SUBJECT: NuScale Power, LLC Response to NRC Request for Additional Information No. 222 (eRAI No. 9116) on the NuScale Design Certification Application

REFERENCE: U.S. Nuclear Regulatory Commission, "Request for Additional Information No. 222 (eRAI No. 9116)," dated September 12, 2017

Enclosure 1: NuScale Response to NRC Request for Additional Information eRAI No. 9116

NRC Question No.: 09.02.07-4

Figure 1.2-2: NuScale Functional Boundaries

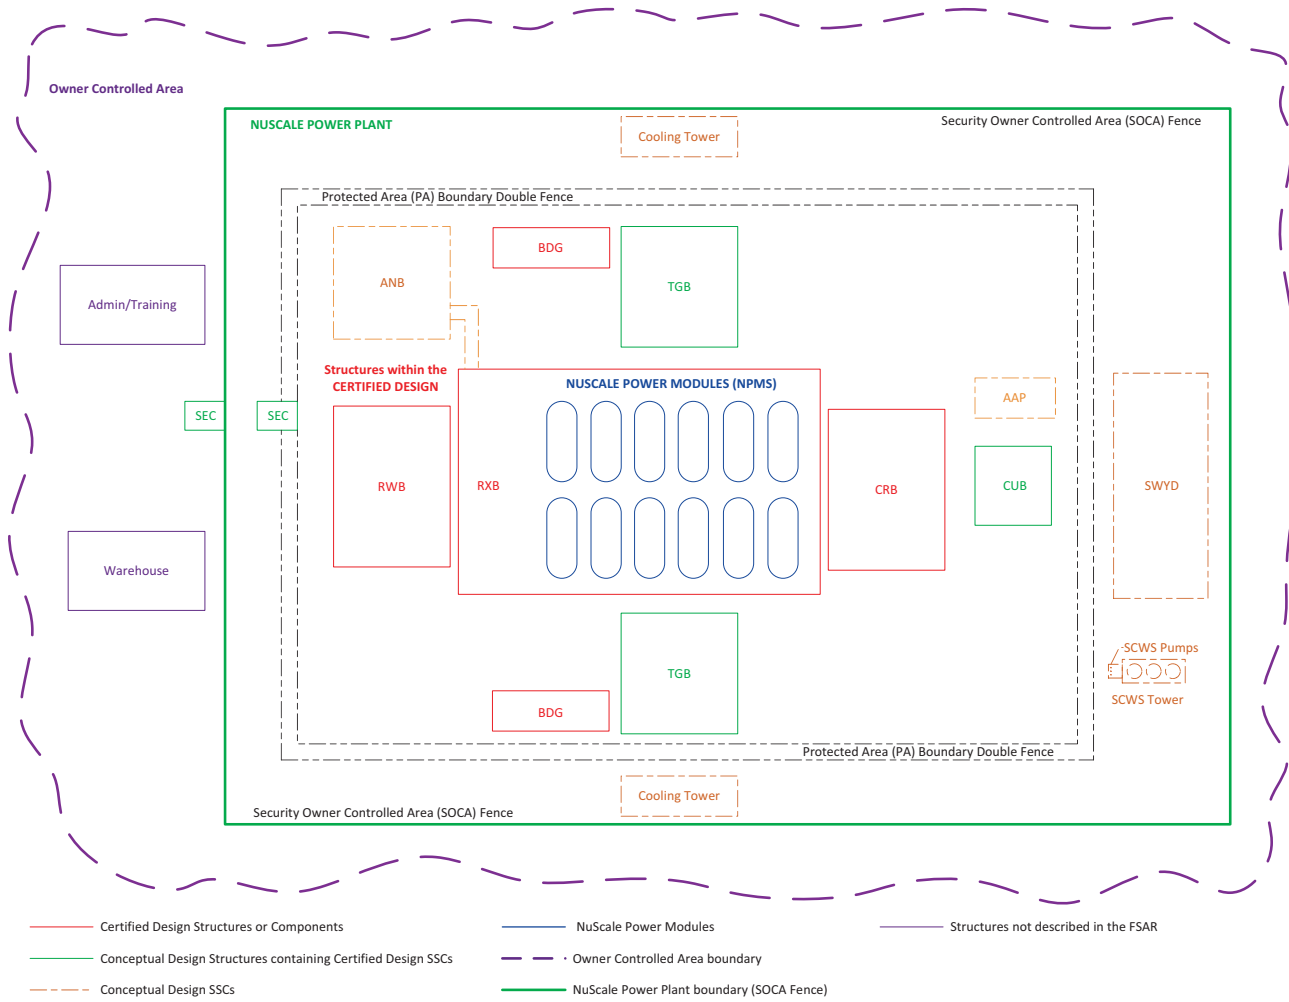
The applicant is requested to provide in the FSAR a description of which portions of the SCWS are part of the design certification and which are considered site-specific or conceptual design information, and appropriately identify the site cooling water tower and pump structure in Figure 1.2-2.

FSAR Tier 2, Section 9.2.7.3 states the SCWS is located sufficiently far from any Seismic Category I or II structures, or safety-related components; in addition, FSAR Tier 2, Table 3.2-1 states the SCWS is located in the yard. These statements contradict the system design which, in part, provides supply and return cooling water to reactor component cooling water system, reactor pool cooling system, spent fuel pool cooling system. Also, FSAR Tier 2, Figure 9.2.7-1 illustrates the SCWS as providing cooling water to the Reactor Building.

FSAR Section 1.2.1 has been revised to list the SCWS as CDI. FSAR Figure 1.2-2 has been revised to show the proposed location of the SCWS pumps and cooling tower. In addition,

FSAR Figure 1.2-2 has been revised to show the proposed location of the site cooling water system (SCWS) pumps and cooling tower. In addition, FSAR Table 3.2-1 has been revised to show that the location for the SCWS components is “various” instead of “yard.” The location of the SCWS letdown line radiation monitor is still the yard.
